Problem # 8 – MnDOT Questions Regarding Bridge Barriers

DATE: April 14th, 2011

SUBJECT: Discussion Regarding Barriers & Barrier Transitions with Staff from the Midwest Roadside Safety Facility (Univ of Nebraska, Lincoln)

Typical Mn/DOT Bridge Barrier Placement

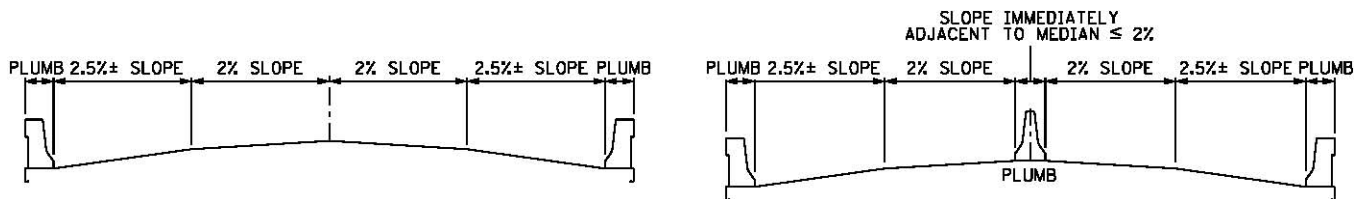
#1). Mn/DOT's current policy regarding placement of traffic barriers on bridges is to place them "plumb" or "level" as indicated in the drawing below.

Based on simulation and testing of 3 barrier types, the MwRSF suggested consideration of different guidance depending on the cross slope of the roadway/bridge;

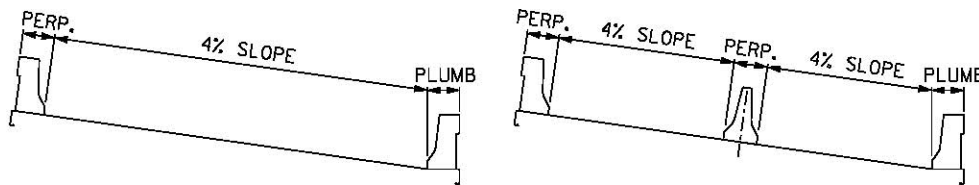
a) for driving surfaces with a normal crown section the barriers may be constructed plumb or “level”, as shown in the sketch below:

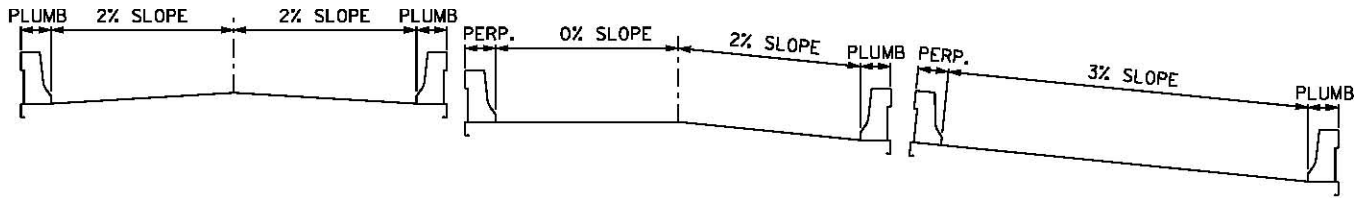
b) for driving surfaces with a constant cross slope or superelevation exceeding 2%, the angle between the bridge deck or roadway and the vertical axis of the barrier should not exceed 90 degrees as shown below:

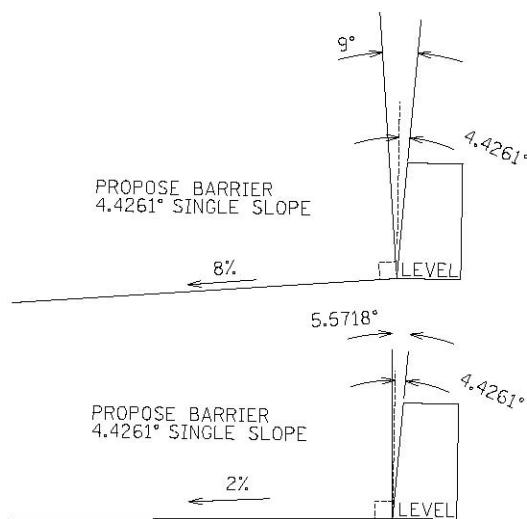
If Mn/DOT eventually adopts a single slope barrier the relative change in slope between barrier face and roadway surface should be limited to about 9 degrees. And, since barriers tested with either a vertical face or a single slope with a 9 degree slope both performed well, it was suggested that, logically, any slope between vertical and 9 degrees should perform well.

Therefore a slope that, when mounted 'plumb' on a deck from 2% - 8% slope would result in a single slope not to exceed the acceptable 9 degrees (measured normal to the deck). Hence, a single slope barrier with a 4-5 degree slope may ultimately become a preferred shape (see sketch below).

MwRSF believes that there is a strong potential that this may be feasible. However, the previous safety shape and single slope testing that these geometric recommendations are made on were not evaluated using the MASH vehicles and impact conditions. Thus, further study may be required to verify this recommendation.

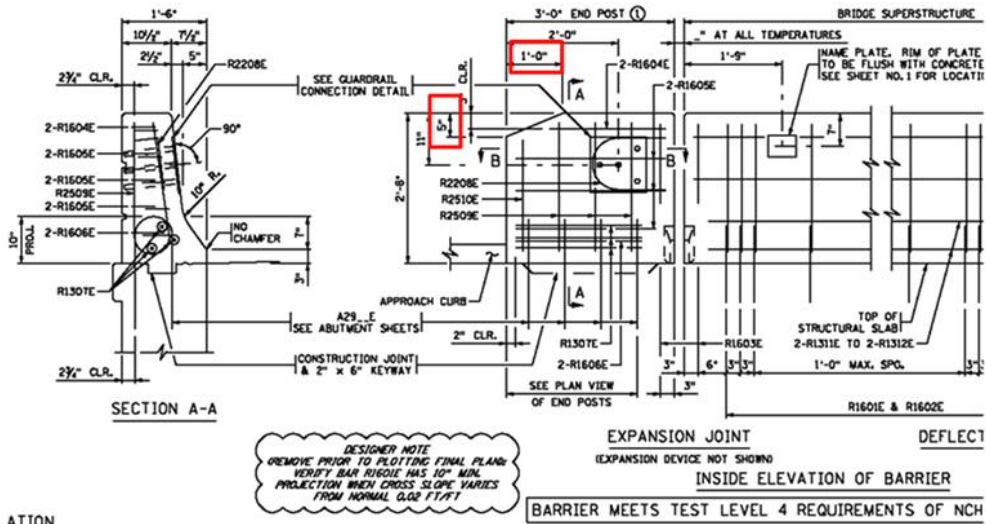
#2). Mn/DOT's current policy on when to use TL-5 barrier (42" high) on a bridge (in lieu of 32" high TL-4) includes the following criteria; Degree of curvature > 5 degrees (radius of 1145 ft) and speed > 40 mph. Other states in our region have been considering guidance that would implement TL-5 barriers more frequently.

It was decided that Mn/DOT will maintain its existing policy regarding use of TL-5 barriers until completion of the 22-13(3) research.

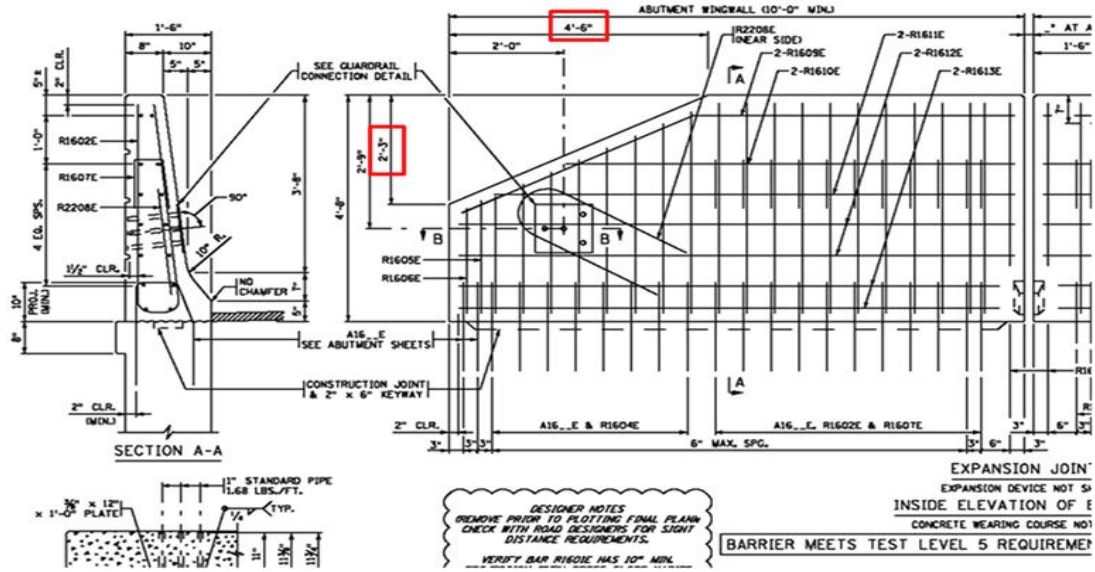
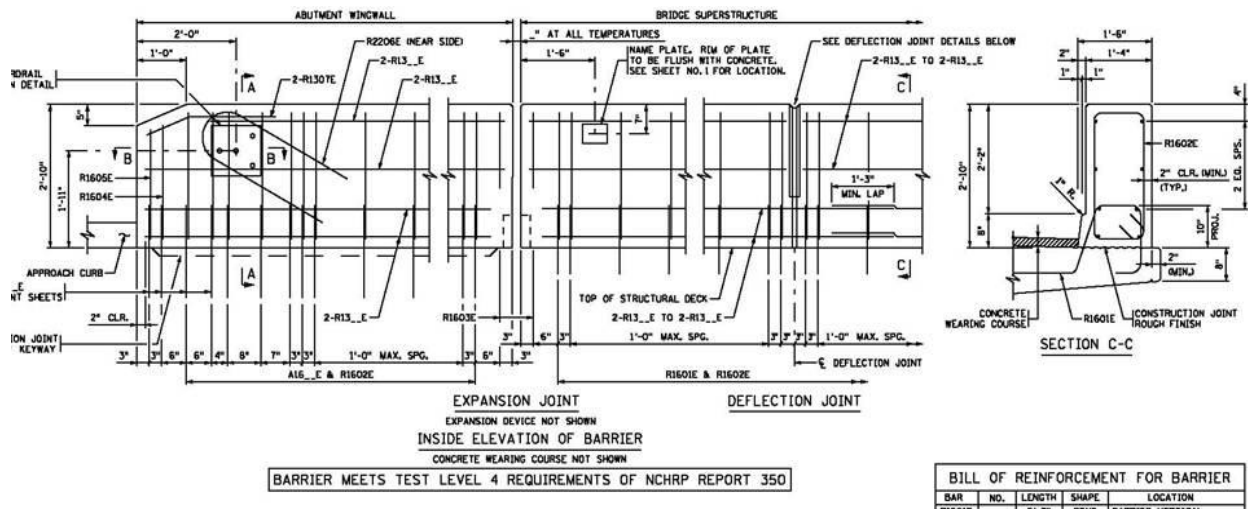
#3). At the end of a 32" or 34" tall concrete barrier, where it transitions to a guardrail connection, Mn/DOT details a slight slope (5V:12H) to the top of the barrier (see top sketch below). What is the appropriate slope or taper length that should be used when transitioning from a 42" (or taller, glare screen barrier that is 4'6" tall, 6V:12H taper) barrier to a guardrail connection?

The 5V:12H taper shown on the end of the 32" and 34" tall Mn/DOT TL-4 barrier has been crash tested and is okay to remain as is. End tapers for barriers taller than 34" should be modified to 1V:8H. The Bridge Standards Unit will put a "temporary hold" on tall bridge barrier standards (>34") showing the 5V:12H taper and begin the process of revising the standards to 1V:8H. #4). Mn/DOT has developed a vertical face bridge barrier as shown below. Other states have developed single slope barrier faces. What are the advantages, disadvantages and design considerations for the various shapes?
